Transportation Impact Assessment

PROPOSED GAS STATION DEVELOPMENT

8605 Campeau Drive, City of Ottawa

**Re: Transportation Impact Assessment - Addendum
Proposed Gas Station Development
8605 Campeau Drive, City of Ottawa
Our Project No. NT-20-091**

DESIGN BY: K.A.	DATE: June 11, 2021
CHECKED BY: R.P.	PROJECT NO: NT-20-091
DRAWN BY: K.A.	DRAWING NO: Figure 7-2
SCALE: NTS

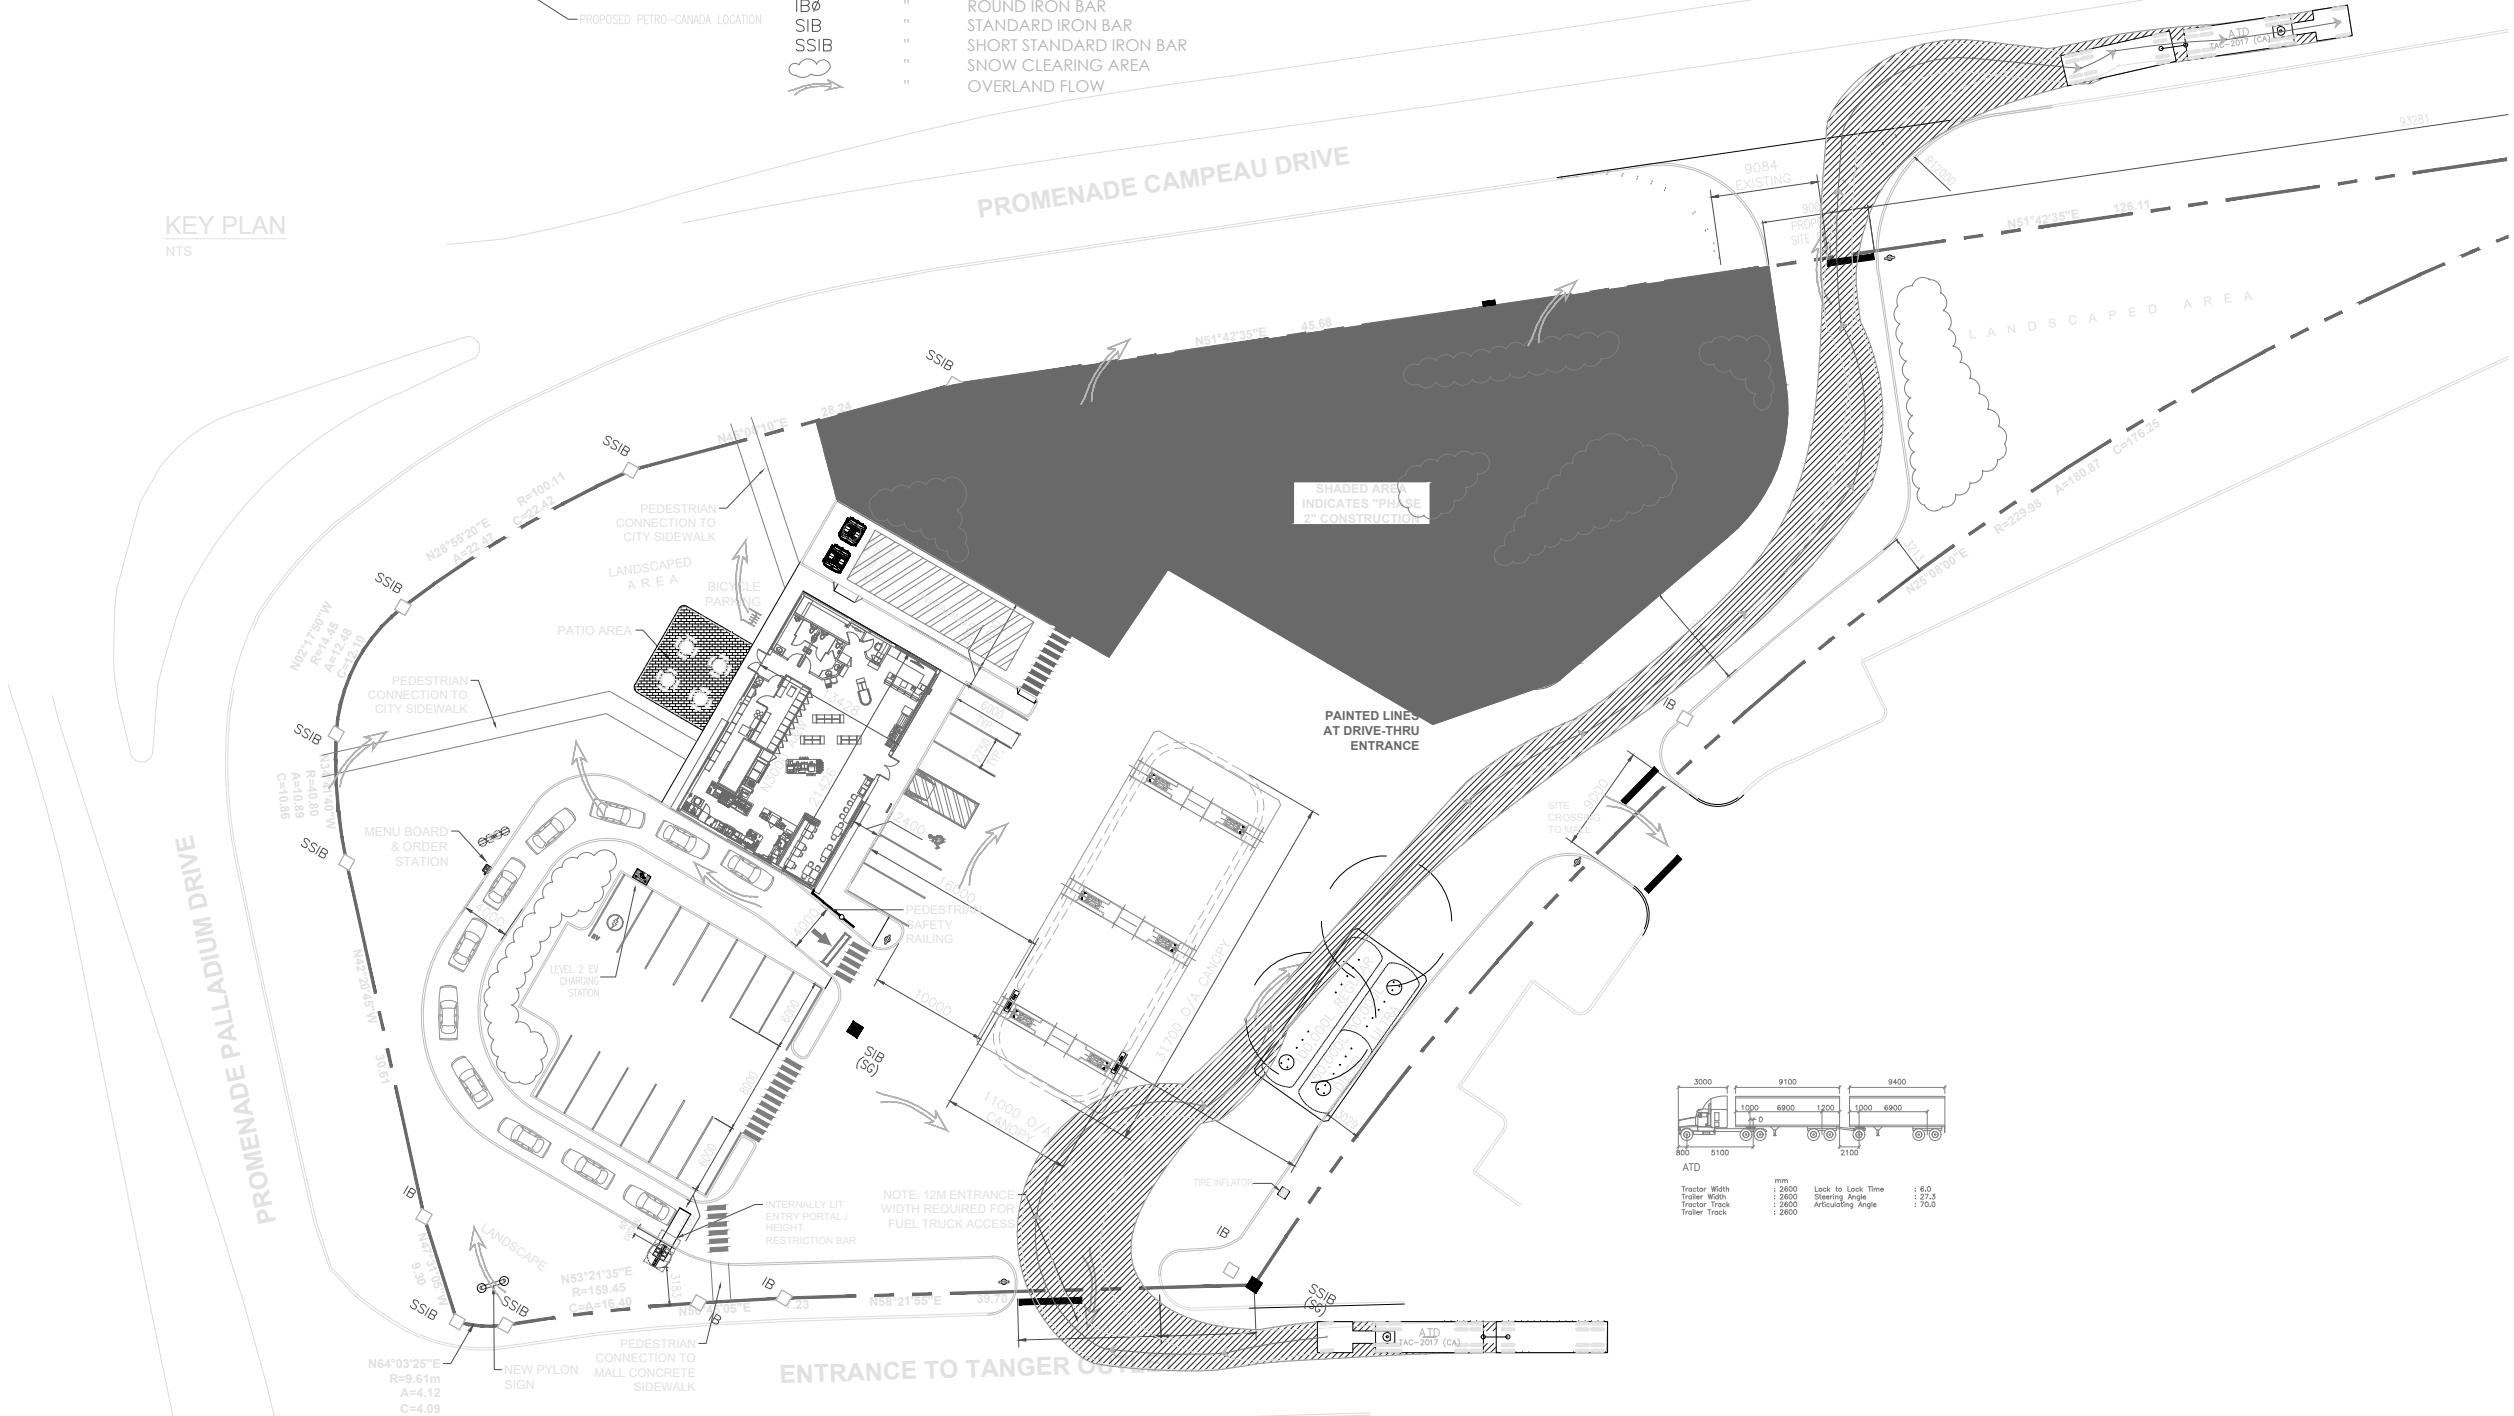
WB-19 truck movements from the arterial should be initiated from the curb side lane or at most straddle the white line of the adjacent lane. Use base mapping that accurately shows the road width and lane markings.

Response: See Figure 7-2.
